TECHNICAL BULLETIN

No: LTB00296 (ISSUE 1)
18 FEB 2011

RANGE ROVER

Upper Glove Compartment Rattle

Figure 1

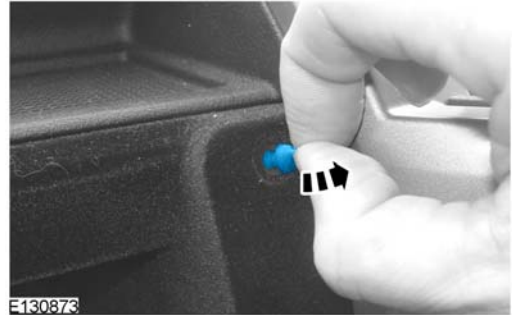
Situation: The upper glove compartment may exhibit a rattle. This may be caused by the upper glove compartment lid bump stop(s) being worn.

1. Open the upper glove compartment lid
2. Remove the existing right-hand (RH) bump stop from the compartment liner. (Figure 1)
